STAFF RECOMMENDATION 1809 Holly Street March 17, 2021 Metropolitan Historic Zoning Commission Sunnyside in Sevier Park 3000 Granny White Pike Nashville, Tennessee 37204 Telephone: (615) 862-7970

**Application:** New Construction—Infill

**Description of Project:** The applicant proposes to construct a new one and one-half story infill oriented to Holly Street. The house will be a duplex.

Site Plan

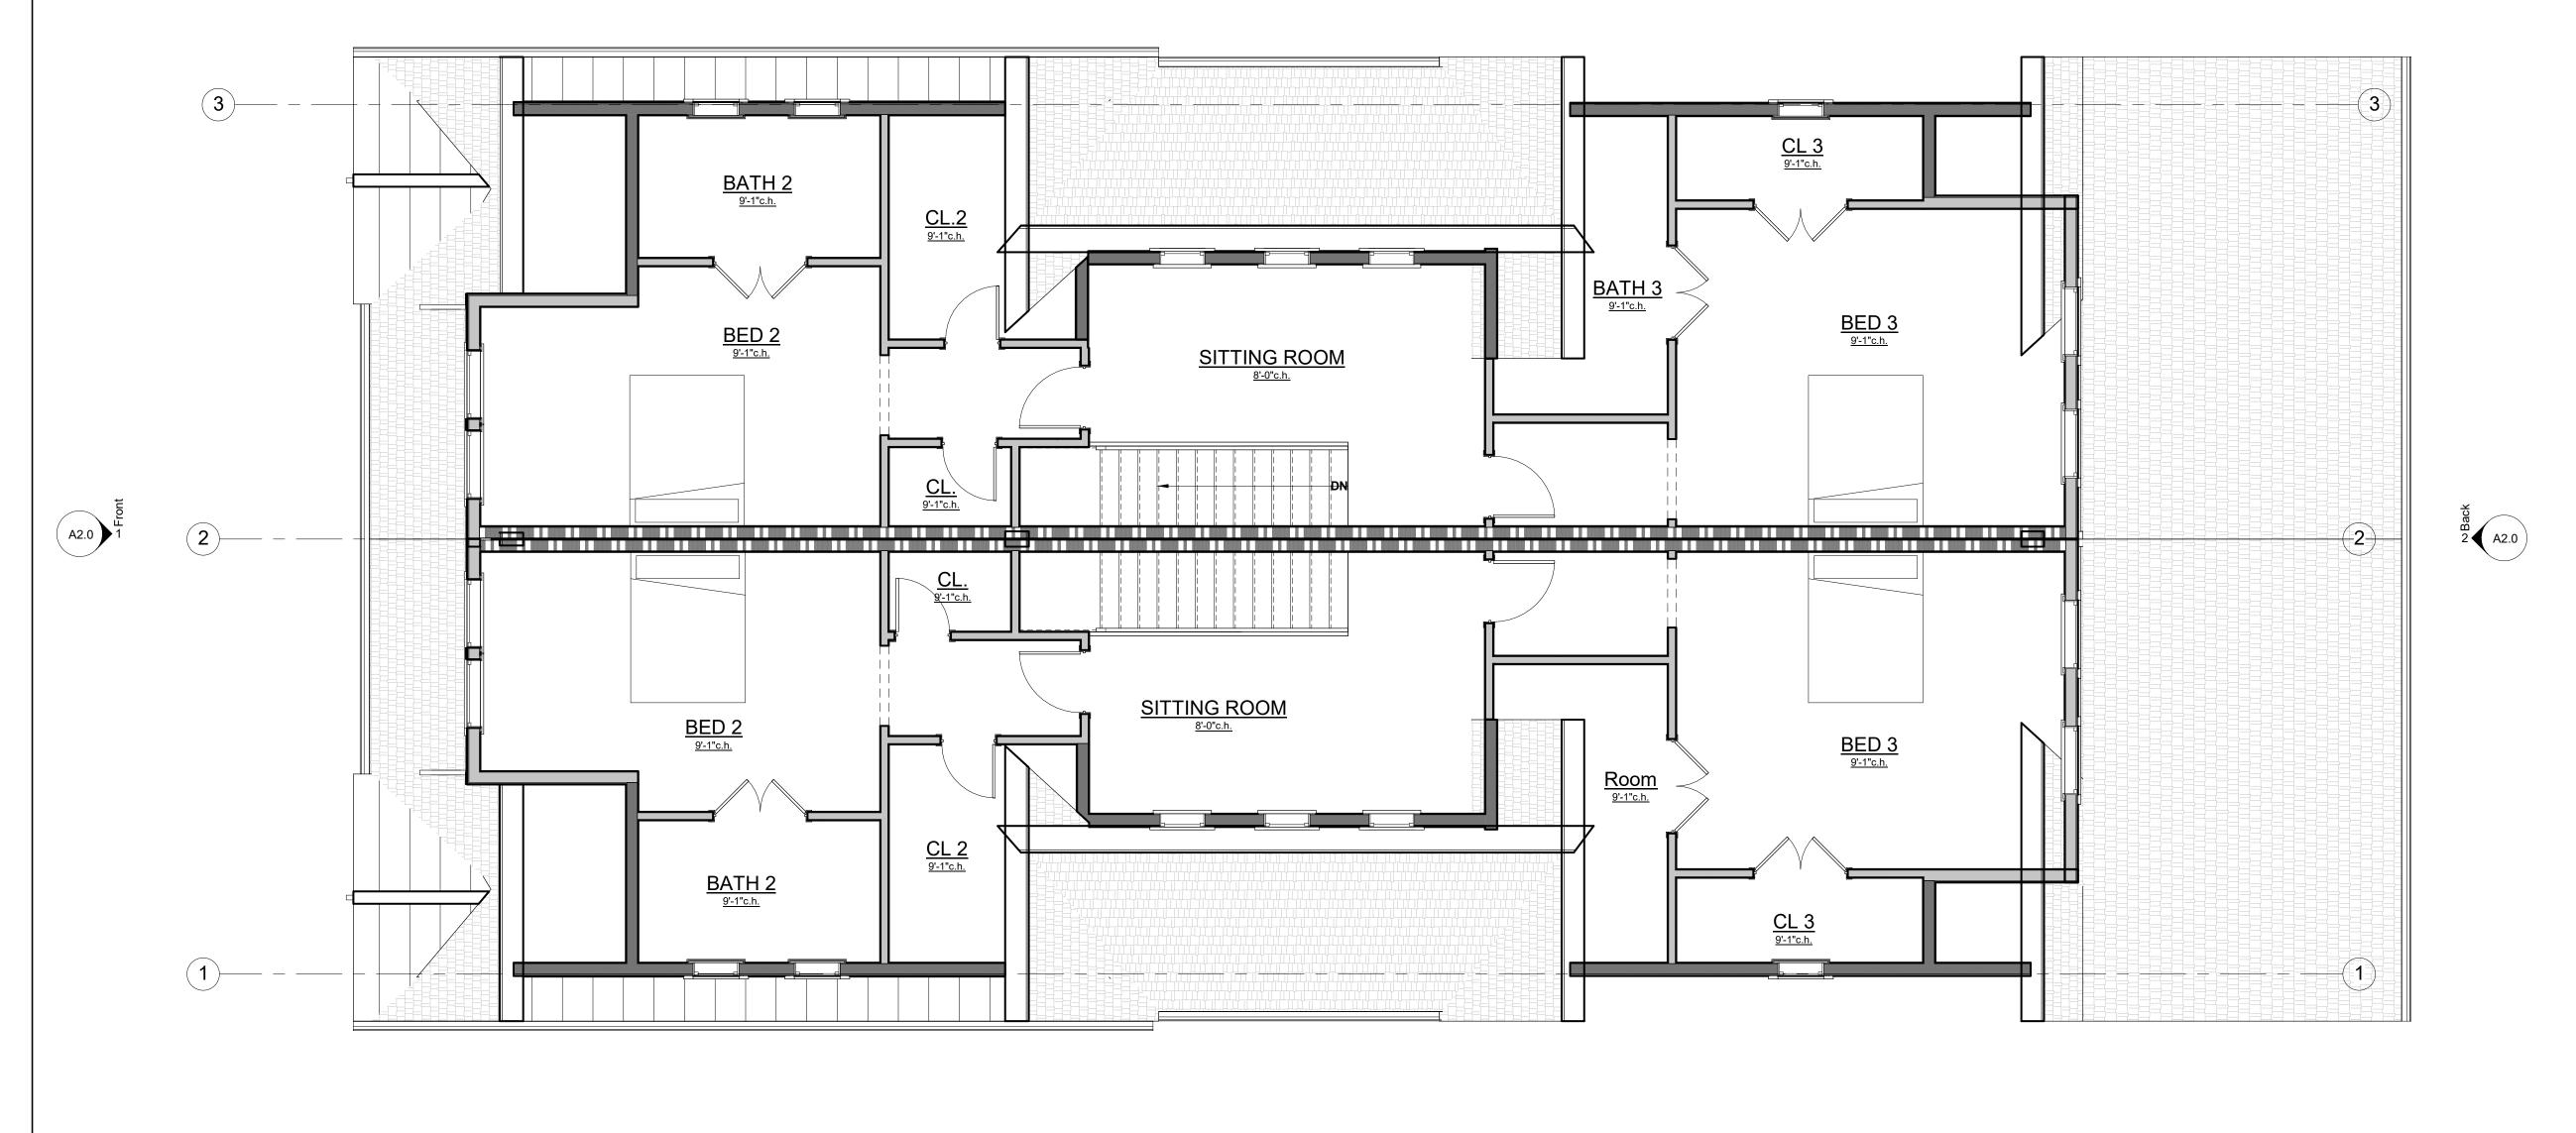
<u>Setback & Rhythm of Spacing</u>: The front setback of the building is proposed to be twenty-four feet (24') from the front property line. This similar to the front setback of the historic house at 1807 Holly and the front setback approved for the infill at 1813 Holly Street.

The proposed house sits off-center on the lot to accommodate a driveway, which is typical of many historic buildings in the immediate vicinity. The right-side setback is five feet (5') which meets bulk zoning standards. The left-side setback is approximately seventeen feet (17'). The infill will be approximately fifty-eight feet (58') from the rear property line. The infill's location on the lot is compatible with the rhythm of spacing along this side of Holly Street.

<u>Appurtenances & Utilities</u>: The location of the HVAC and utilities were not noted on the plans. Staff recommends that the HVAC be located behind the house or on

either side, beyond the mid-point of the house, and utility meters shall be located on the side of the building, within 5' of the front corner. Alternative mechanical and utility locations must be approved prior to an administrative sign-off on building permit(s).

Front/Rear Elevations

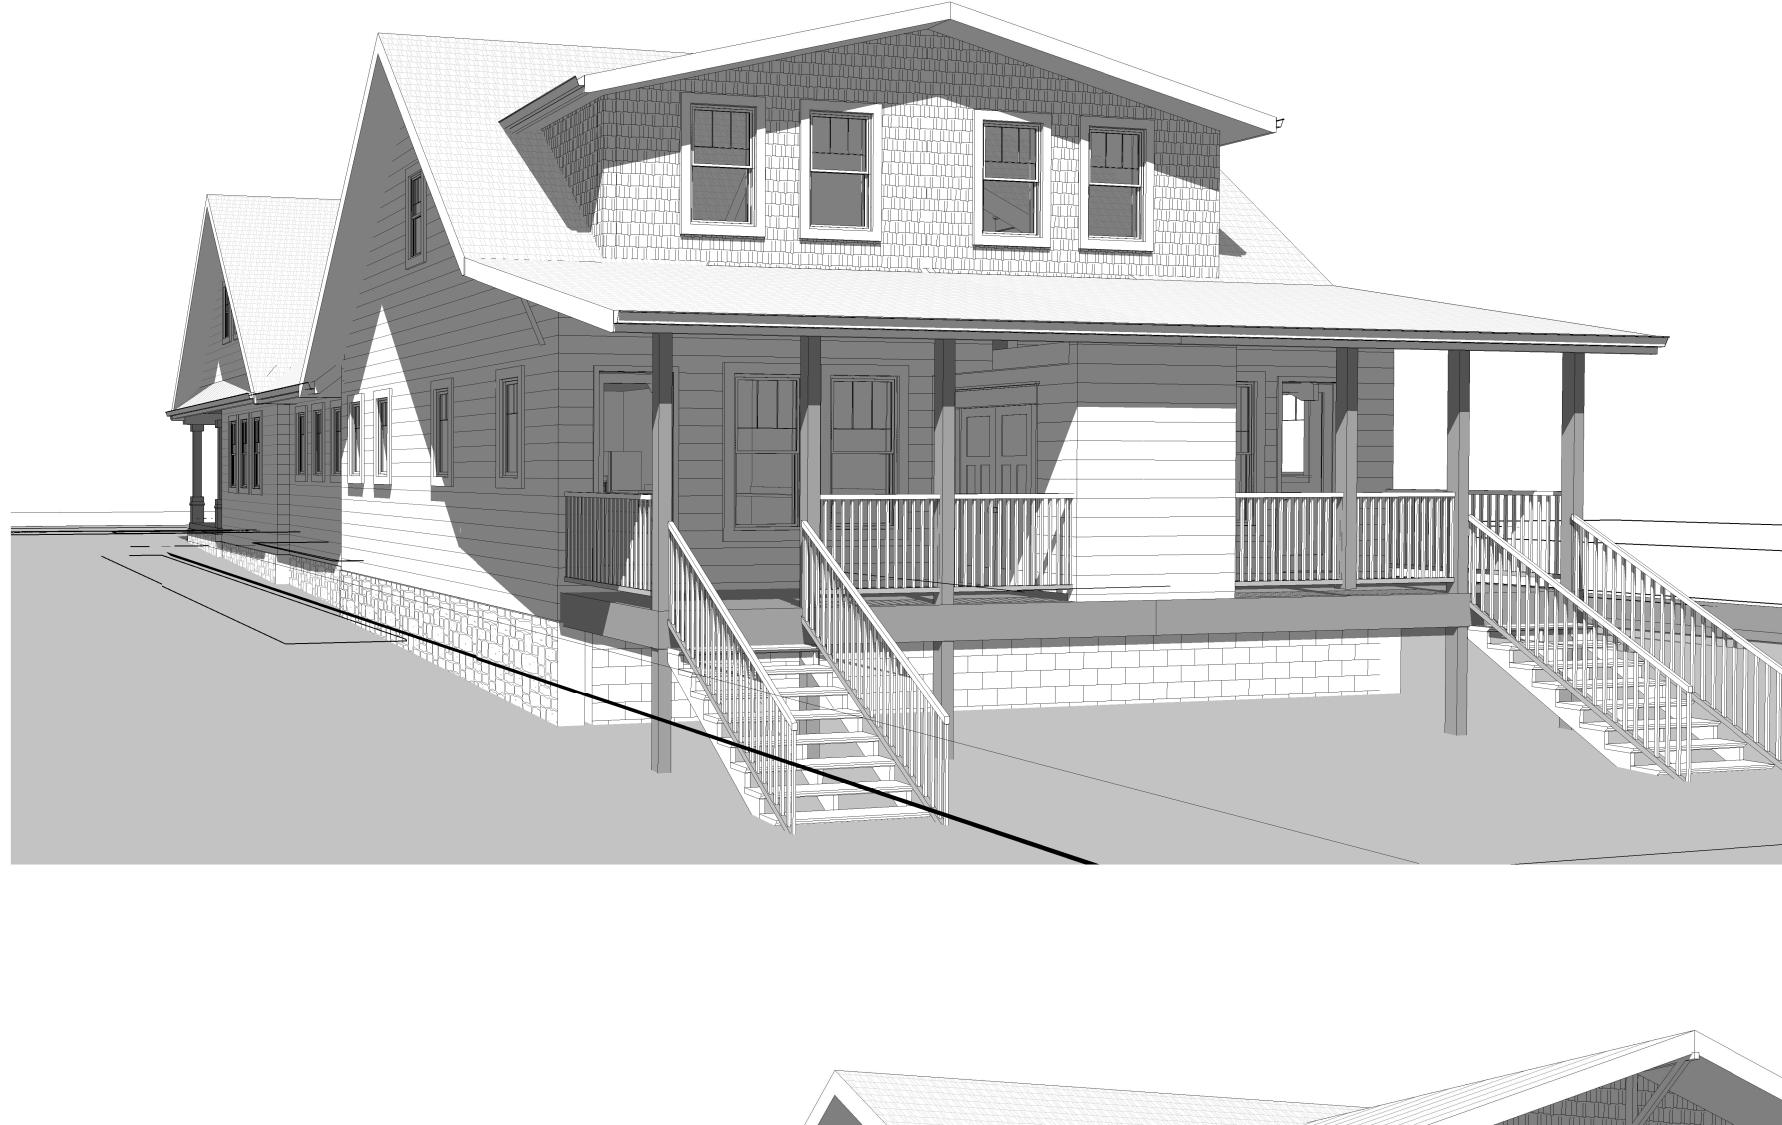
<u>Height & Scale</u>: The new building will be a one and one-half-stories, which is compatible with the historic houses on the block and the surrounding area. The house will be twenty-six feet and six inches (26' 6") tall from the front grade to the peak of the roof. The immediate context ranges from an estimated nineteen feet (19') to twenty-nine feet (29') in height on similar sized lots. In 2020, MHZC approved infill next door at 1813 Holly Street to be also one-and-a-half stories and twenty-seven feet (27') tall. The foundation is approximately one foot, nine inches (1'9") tall and the eaves are less than ten feet (10') from finished floor, both of which match the historic context.

Roof form: The primary roof of the building will be a side-gable with a 11/12 pitch. There's a 9/12 gable connector to another 12/12 side gable. The front and rear dormers will be gabled with a 4/12 pitch on the front with a 3/12 pitch in the rear. The front dormer is inset two feet (2') from the wall below. In the connector will be 3/12 shed dormers. The front stoops will have 12/12 gable. These roof forms are all compatible with the historic roof forms in the immediate vicinity.

<u>Proportion and Rhythm of Openings</u>: The window openings on the infill are all vertically oriented, meeting the historic proportion of window openings. There are no large expanses of wall space without a window or door opening.
